CONDITIONS OF APPROVAL:

Engineering - Site Plan Checklist

15058 PUD Site Plan Pre-App Submittal.pdf

Southwestern corner of the building:

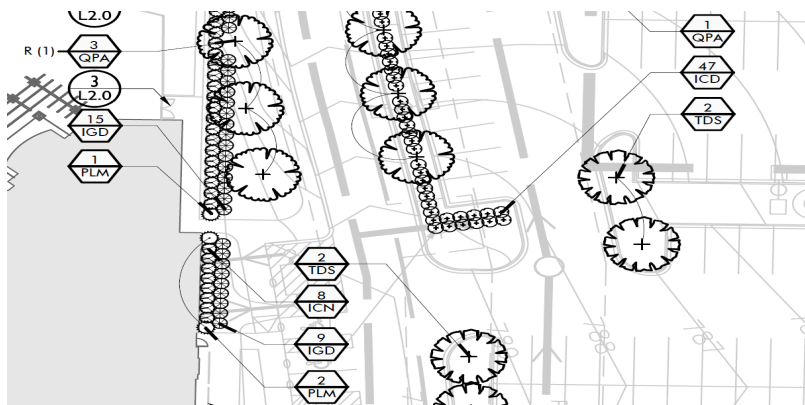
- The applicant has not fully addressed the comment/concern regarding the coordination of landscaping and utility plan sheets.

L1.2 continues to indicate landscaping "on top" of the proposed fire hydrant which requires a minimum of three (3) feet of clearance to the sides and rear and no obstruction to the front.

The applicant is again asked to coordinate the landscaping sheets to prevent conflict with utility infrastructure and fire protection equipment.
